Graphics Textiles Ltd (Extension)

Sreerampur, Kalampurm Dhamrai, Dhaka
(23.919336, 90.124829)

18th April 2022

Stressed columns in layout (yellow marked)

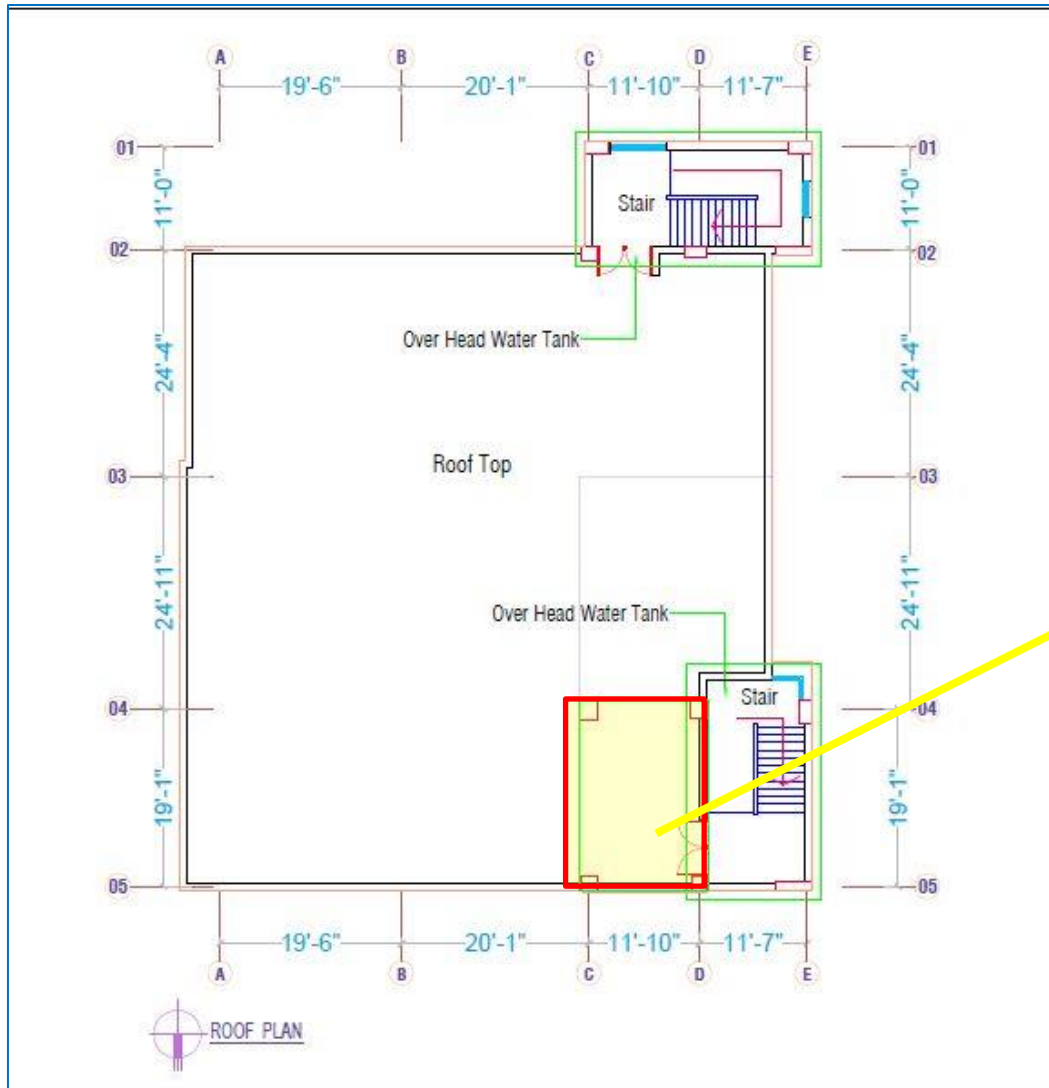
Stress in column exceeds normal design limit

The cursory calculation indicates that some column's stress exceeds the normal design limit considering a typical floor live load 5kPa, roof live load of 1.5 kPa, and concrete strength of 16.31 MPa. The building engineer is required to review the design, loads, and column stresses for the marked columns based on in-situ material strength.

Verify in-situ concrete stresses by 100 mm diameter cores from a minimum of 4 columns. Produce and actively manage a loading plan for all floors considering floor and column capacity.

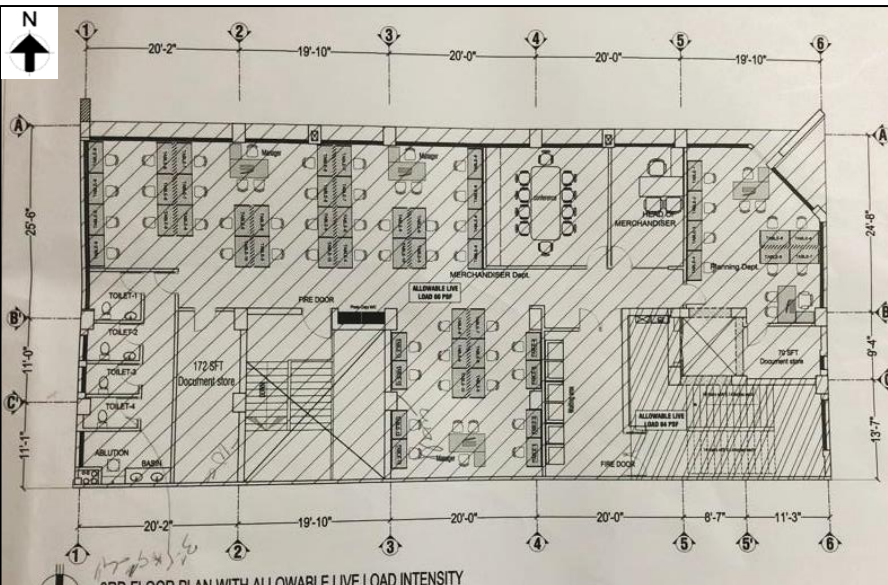
In E-tabs software, Wind speed considered 125 mph
and Windward Coefficient considered 1.68

As per BNBC, wind speed for the Dhaka zone was required to be considered 130.49 mph but 125 mph is considered in the analysis software "E-tabs". Also, the windward coefficient in Etabs does not match the calculated value. As per the EA report, the windward coefficient is 1.168 whereas 1.68 has been considered in the E-tabs software.

The building engineer is required to revise the analysis software and engineering assessment report for actual wind parameters and submit it to RSC for review.

3rd Floor Layout plan

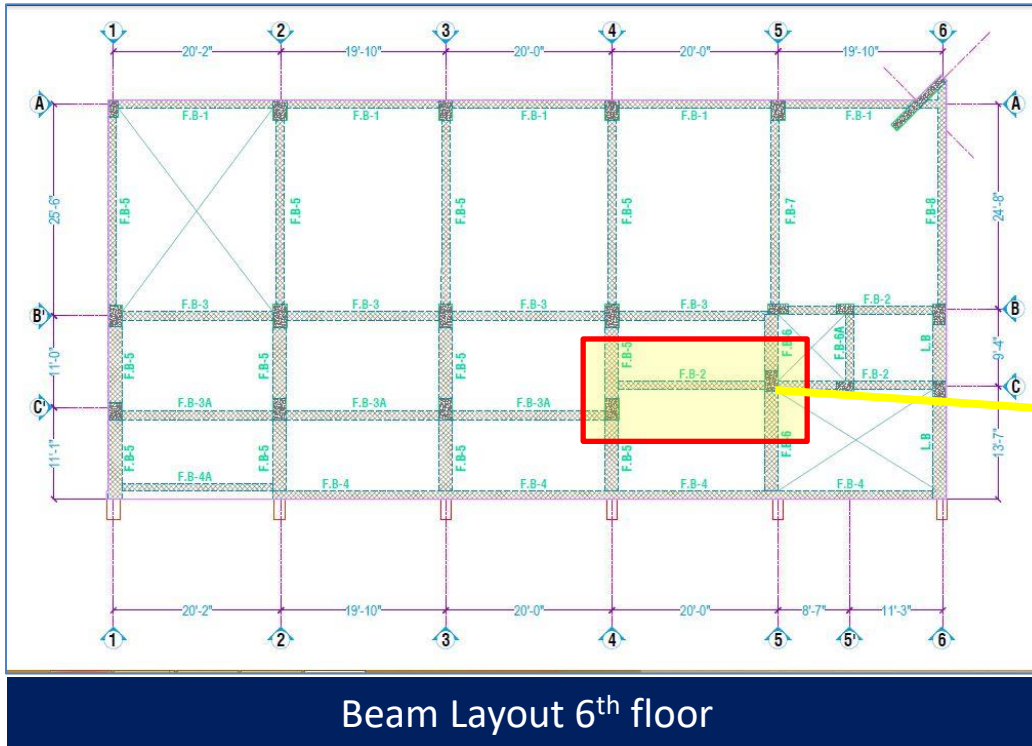
As per load plan of the building, 60 psf (3 kPa) has been shown. But in E-tabs, 80 psf (4 kPa) has been considered in all the floor level and 100 psf at 3rd floor (marked location).

As per BNBC, every building or structure designed shall have its design documents prepared in accordance with the provision of Section 1.9.1. The design document shall include a design report, and a set of structural drawings, which shall be prepared in compliance with section 1.9.1.1 and section 1.9.1.2 as per BNBC. Revise the software-based analysis model, design report and load plan following BNBC requirements.
